AD 2008-13-17

Circuit breaker-type switch replacement

Update 8/21/2008

“Old” breaker

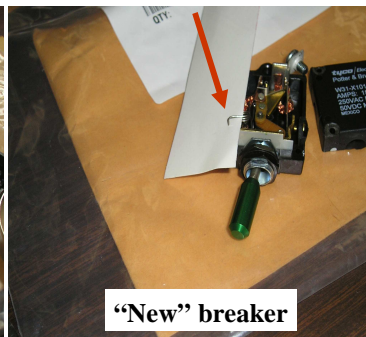
This unused, original Beech part circuit breaker is of the type required to be replaced under the AD. Note the straight end of the spring, indicated by the red arrow. According to Beech technical support and breaker manufacturer Tyco Electronics, the end of this spring scratches insulative material inside the breaker when the switch is cycled, and as the aircraft subpanel vibrates in flight. Eventually, they say, the spring will wear through the insulation, creating the alternative electrical path that leads to overheating and the potential for fire.

“New” breaker

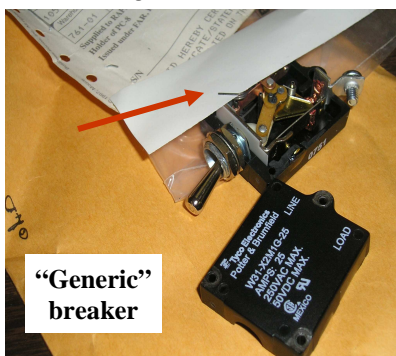
ABS purchased two new breakers from RAPID (two different Beech parts numbers) of the type called out as replacements in the AD. We discovered the spring in each of these parts is bent so that it does not rub against the inside of the breaker when the switch vibrates or is turned on and off.

Tyco says this modification eliminates the failure mode that caused FAA’s concern, and the new-design breaker has been tested to 50,000 cycles without failure.

Consequently, ABS recommends that, if you have a circuit breaker-type switch that gets hot to the touch in operation, that generates smoke in the cockpit, that continually pops under a load, or that you replace to comply with AD 2008-13-17 or for any other reason, that you **only use Beech part number breakers purchased through RAPID** to ensure you have the new-design spring. Note that only Beech part number breakers are called out as AD replacements.
